Subject:
Upper Parker Brothers Channel and Fines Pile Design Clarifications

ASARCO El Paso Smelter Remediation Site

DESIGN CLARIFICATION NO. 3

PROJECT	<u>Upper Parker Bros. Arroyo Fines Pile Cover System and Drainage Improvements</u>	PAGE 1 OF 4 PAGES
LOCATION	<u>El Paso, Texas</u>	PROJECT NO. <u>6835001</u>
		DATE <u>05/16/16</u>
CONTRACTOR	<u>Arcadis Construction and Environmental Services (ACES)</u>	CROSS REFERENCE TO DAILY REPORT NO. _____
INSTRUCTIONS		
<p>Whenever any corrective change is made in field construction which is at variance with the specifications and drawings as originally issued, a complete detailed design clarification shall be filed, listing the following items, so that the designer can review and approve the clarification.</p> <ol style="list-style-type: none"> 1. Identify the area in question: Indicate why originally specified construction was not used or modified. 2. The Solution: Describe, in detail, the recommended change or changes that were made, as applicable. 3. Indicate whether this is an isolated case or a general condition which could be improved by changing future specifications or drawings. 4. Submit sketches as necessary.

EXHIBIT
 UPPER PARKER BROTHERS ARROYO
 AND FINES PILE VE EXHIBIT
 SCALE: NOTED

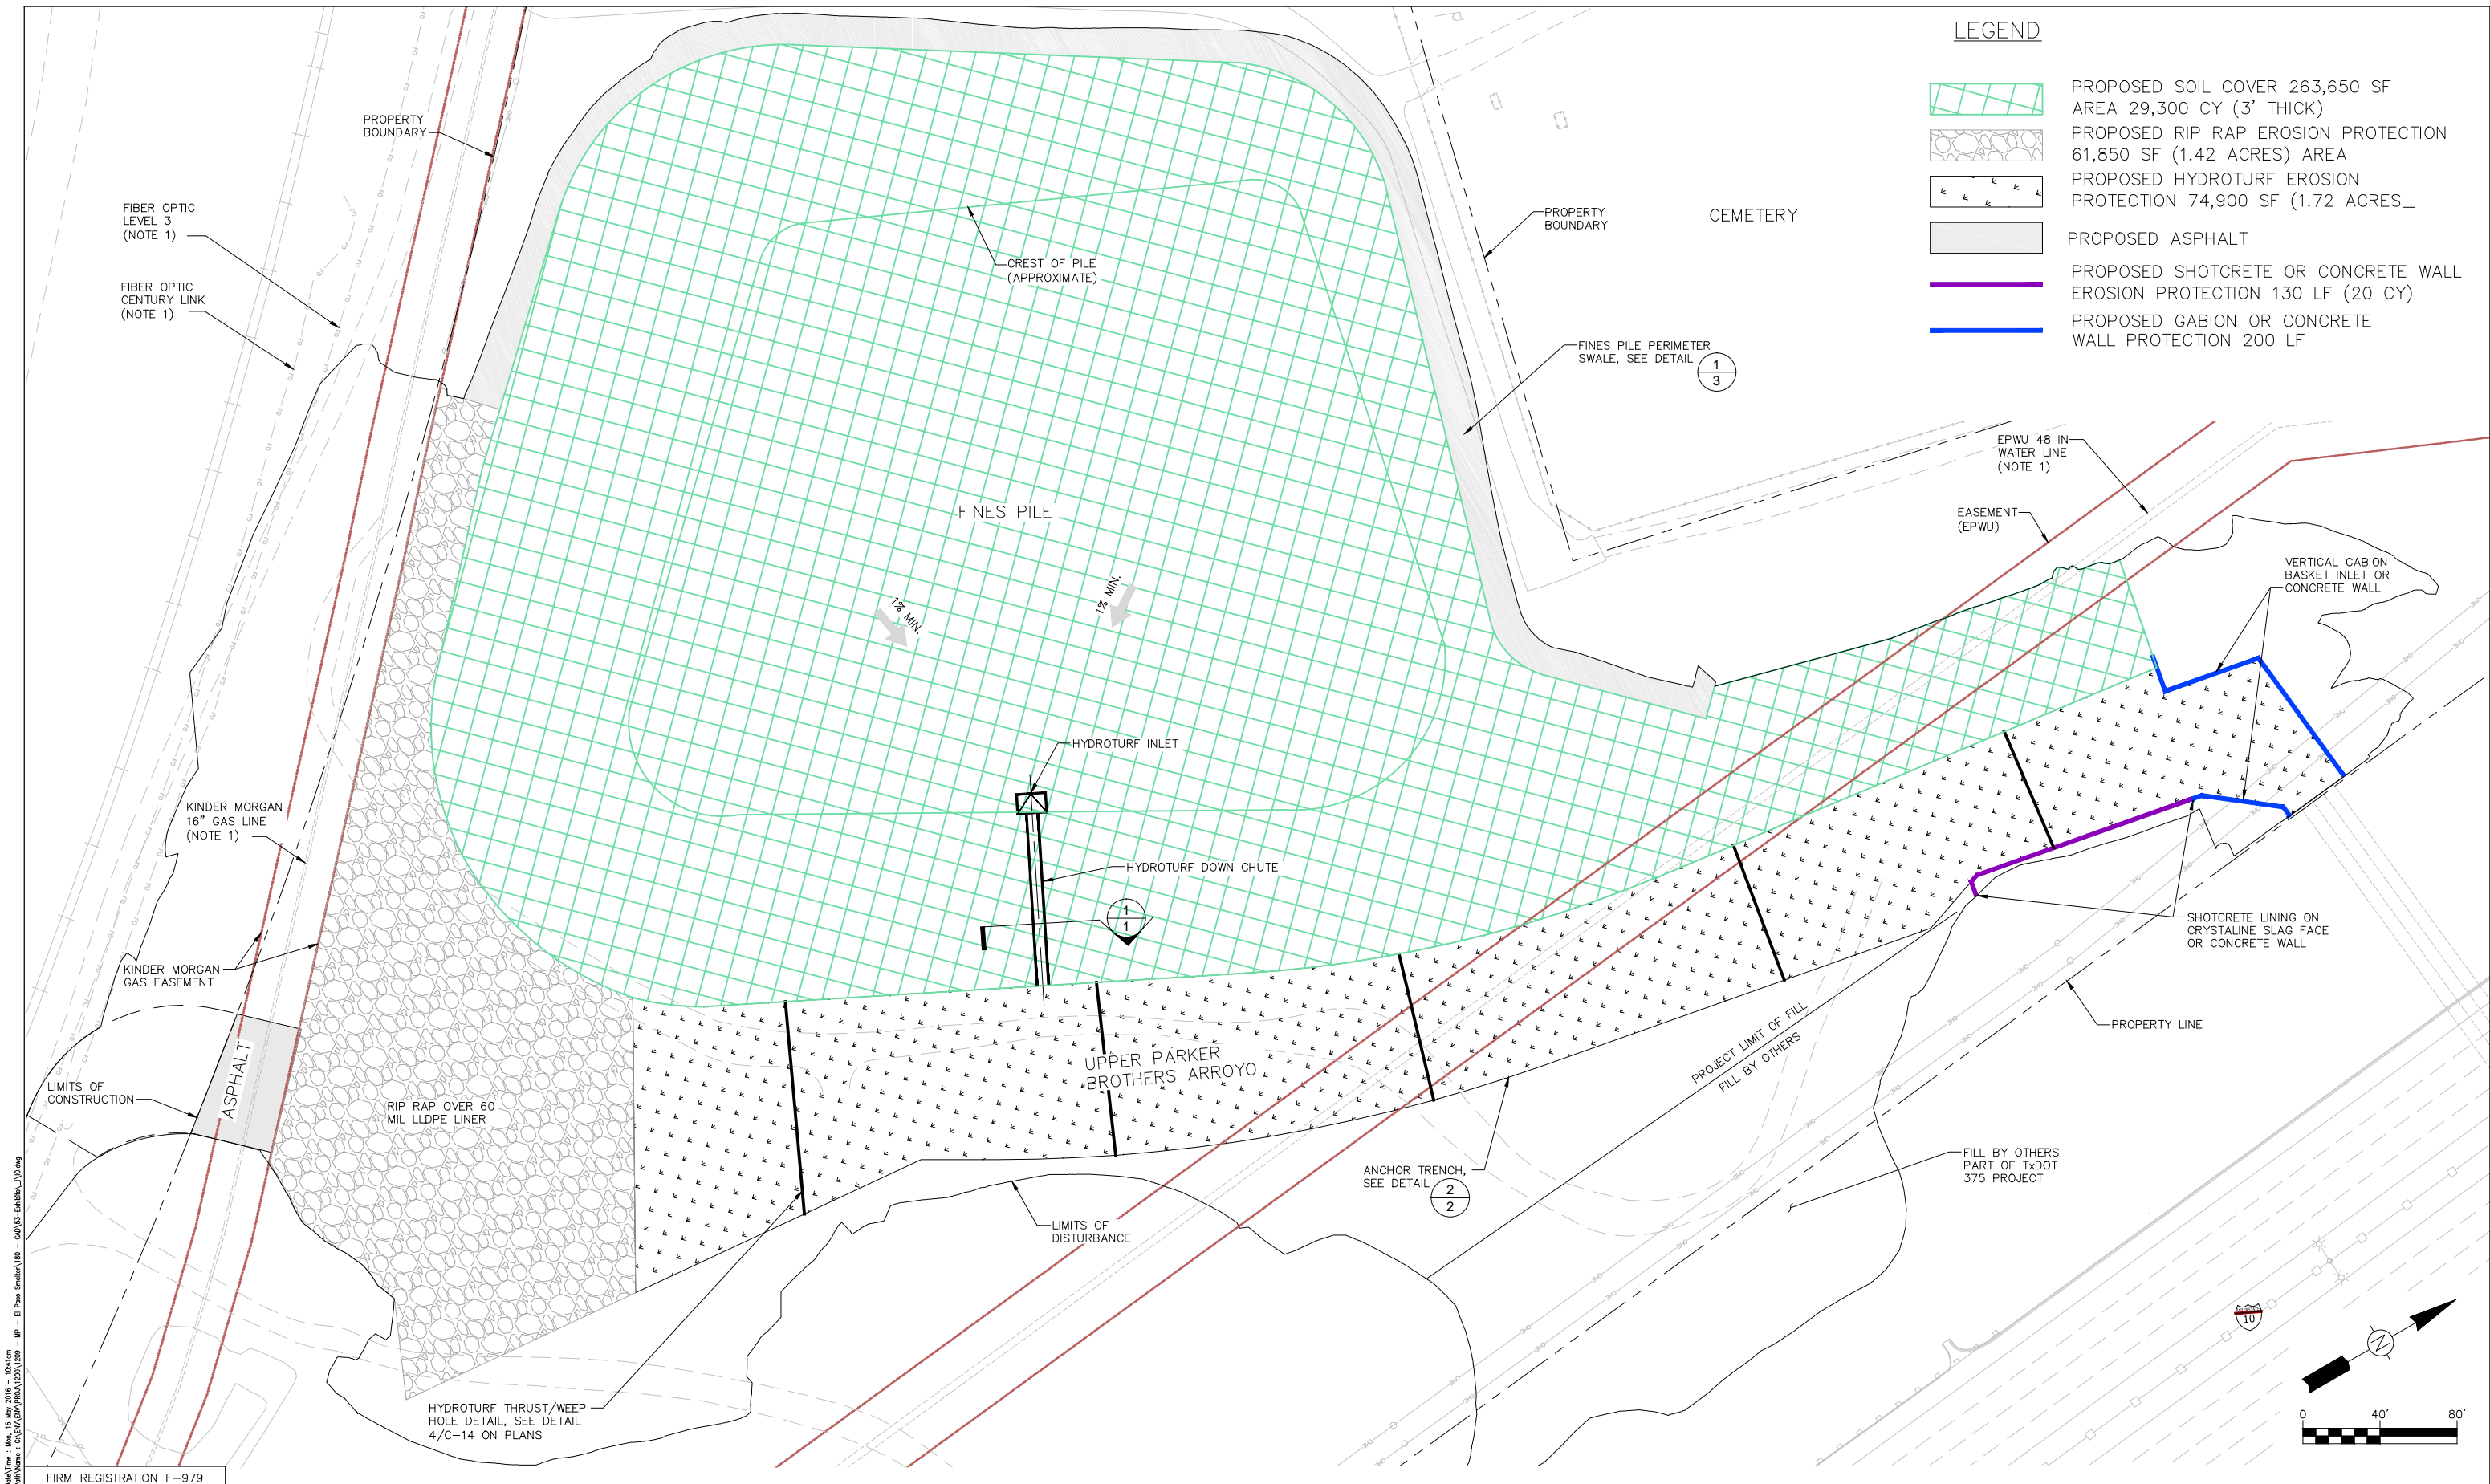
An evapotranspirative (ET) final soil cover will be used on the slopes above the Upper Parker Brothers Arroyo (UPBA), perimeter slopes and top deck. The ET soil cover section will be the same as the approved cover for the sloped area on the plant site. Surface water generated on the Fines Pile top deck will be routed to drain to a HydroTurf lined down drain discharging onto the approved HydroTurf lined UPBA channel. Surface water generated from the the Fines Pile perimeter slopes will be collected in an asphalt lined ditch at the toe of the slopes. The down drain and perimeter ditch are sized to carry the 100-year 24 hour storm to the UPBA channel.

1. DETAILED IDENTIFICATION OF THE AREA IN QUESTION		
Alternative configurations for the Fines Pile and Upper Reach.		
2. DETAILED SOLUTION PROPOSED OR ACCOMPLISHED		
Fines Piles capping method revised from ClosureTurf to ET Cover.		
Ephemeral Pond area liner revised from HydroTurf to Riprap over LLDPE.		
Fines Pile Perimeter Ditch revised from HydroTurf with Riprap to an asphalt liner.		
Upper Reach inlet gabion baskets revised to allow concrete walls or Shotcrete lining (South bank only).

-  PROPOSED SOIL COVER 263,650 SF
AREA 29,300 CY (3' THICK)
-  PROPOSED RIP RAP EROSION PROTECTION
61,850 SF (1.42 ACRES) AREA
-  PROPOSED HYDROTURF EROSION
PROTECTION 74,900 SF (1.72 ACRES)
-  PROPOSED ASPHALT
-  PROPOSED SHOTCRETE OR CONCRETE WALL
EROSION PROTECTION 130 LF (20 CY)
-  PROPOSED GABION OR CONCRETE
WALL PROTECTION 200 LF

EXHIBIT
 UPPER REACH
 CHANNEL DETAILS
 SCALE: NOTED

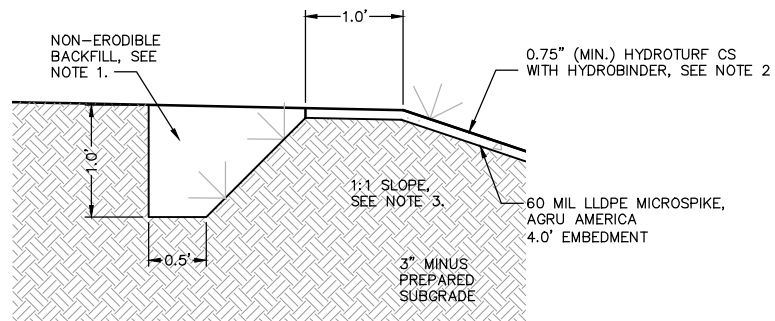
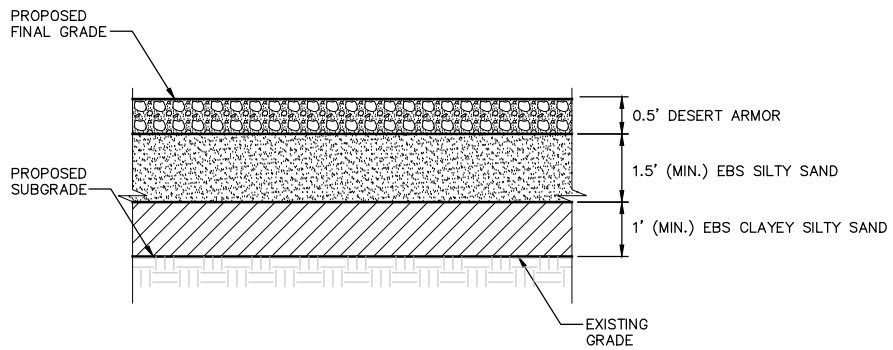
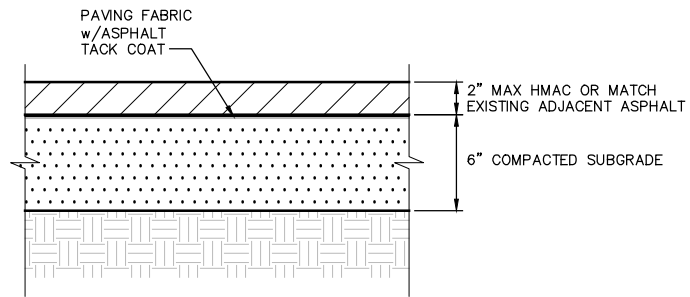
An alternative configuration for UPBA channel inlet (adjacent to I-10) allows construction of a cast in place concrete wall or spraying shotcrete on the south face of the inlet area. Either of these two configurations accomplish the same function as the specified system comprised of a LLDPE liner under gabion baskets to form the channel walls. The concrete or shotcrete will be keyed into the subgrade and sealed using a combination of design details previously approved in the UPBA Fines Pile Cover System and Drainage Improvement Plans.

The UPBA channel extends from the I-10 property line to the flat area adjacent to the Union Pacific Railroad (UPRR) property line known as the Ephemeral Pond. The channel will be lined as originally approved with HydroTurf and the Ephemeral Pond will be lined with LLDPE overlain by a geotextile cushion fabric and riprap, which is the same system approved and used in the Lower Parker Brothers Arroyo Drainage Improvements. The outlet area of the Ephemeral Pond will be lined with asphalt over the Kinder Morgan gas line easement to the UPRR property line. We are coordinating with UPRR to assure the drainage channel termination at the TCT property line is consistent with drainage improvements planned on UPRR property.
